Final Drainage Report  
**Grazing Yak Solar**

El Paso County, Colorado  
April 2019

## Final Drainage Report for Grazing Yak Solar

**MAP NUMBER  
 08041C0625 F**

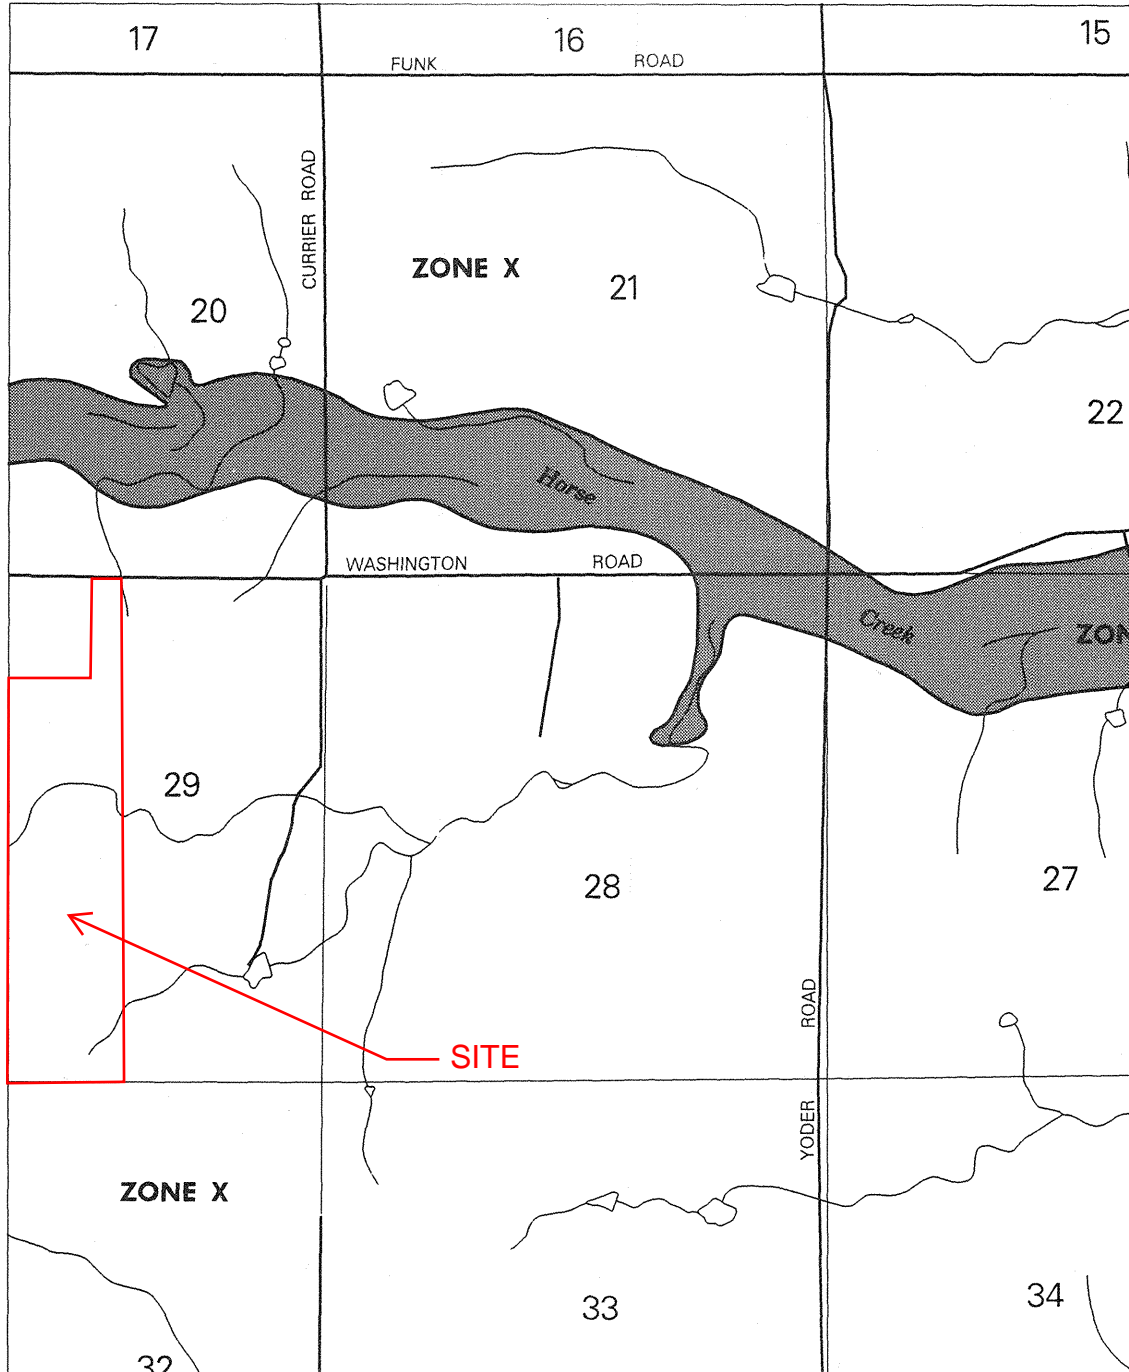
**Up date panel to  
 December, 7 2018  
 FIRM**

**MAP NUMBER  
 08041C0650 F**

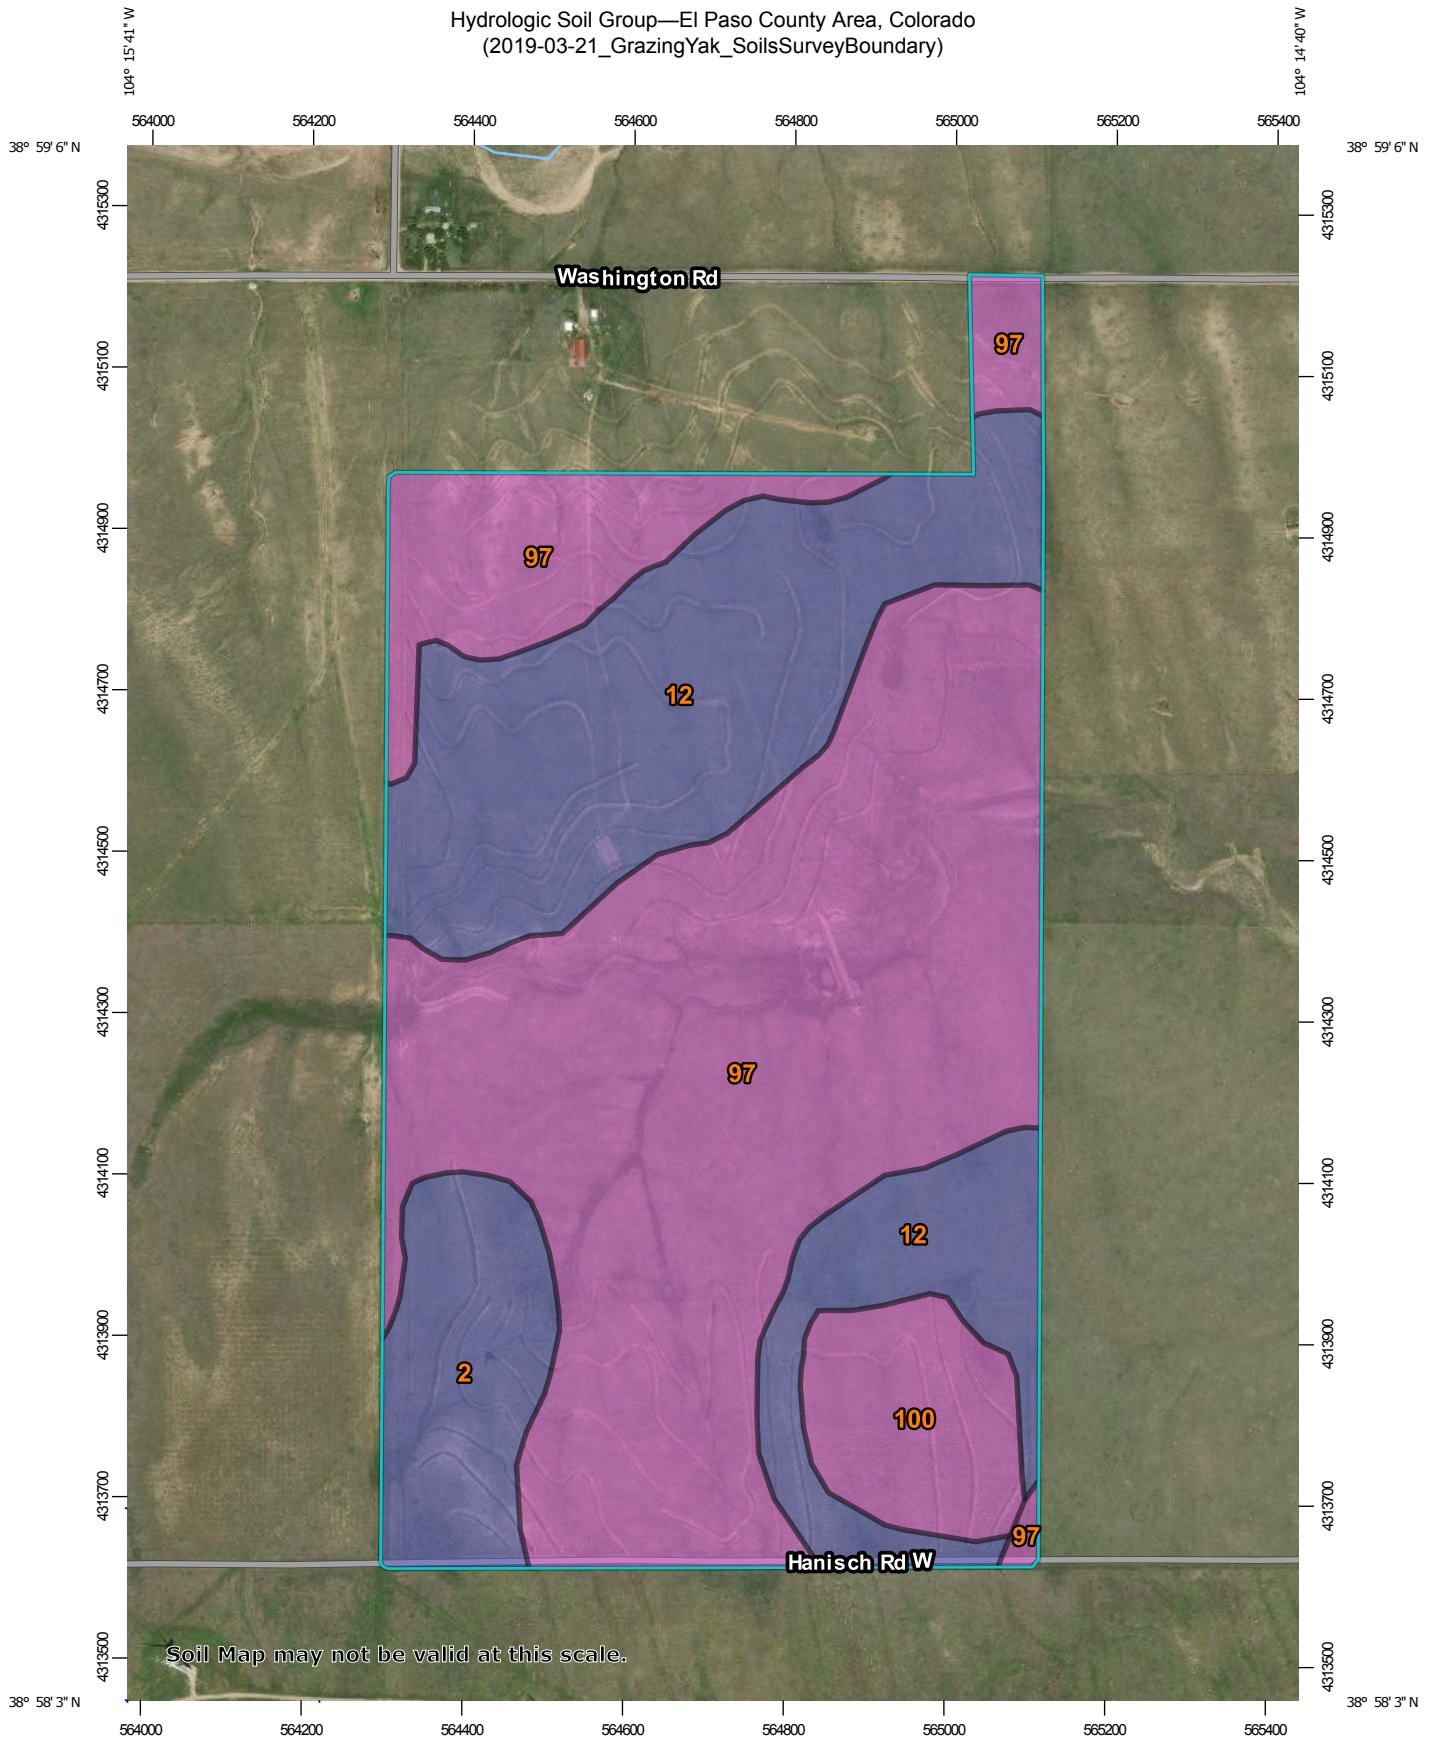
**Up date panel to  
 December, 7 2018  
 FIRM**

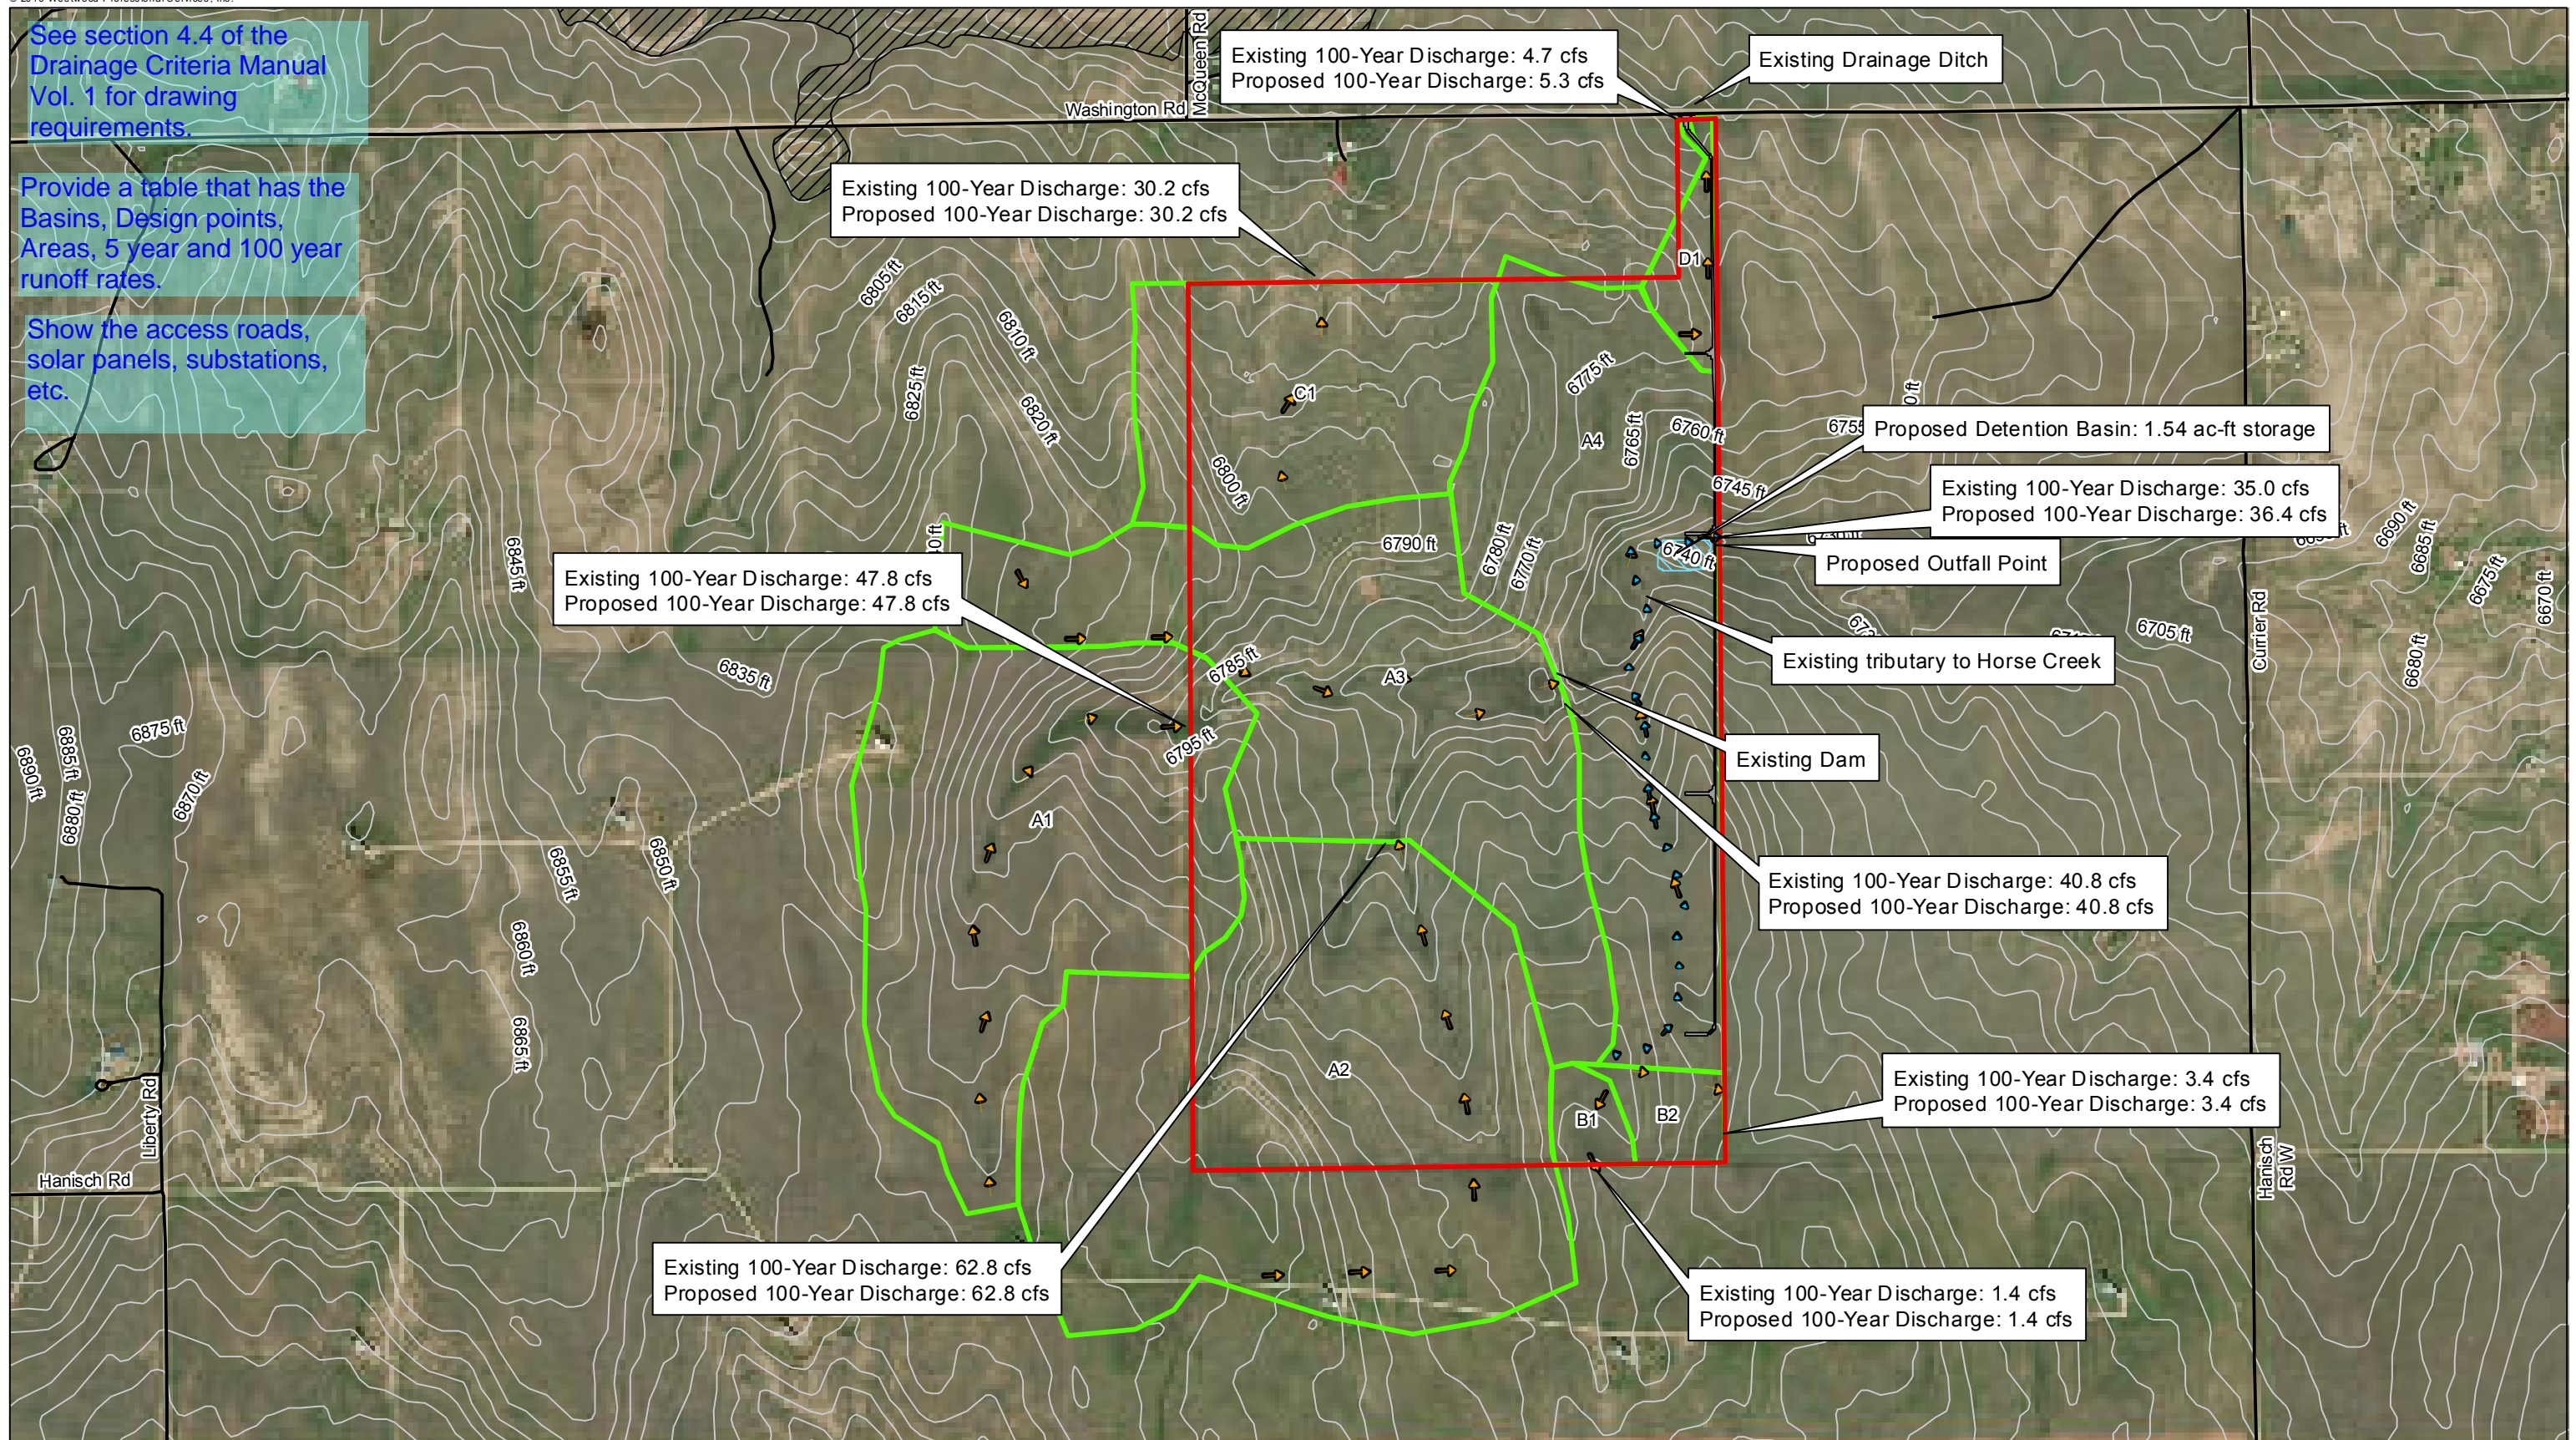
See section 4.4 of the Drainage Criteria Manual Vol. 1 for drawing requirements.

Provide a table that has the Basins, Design points, Areas, 5 year and 100 year runoff rates.

Show the access roads, solar panels, substations, etc.
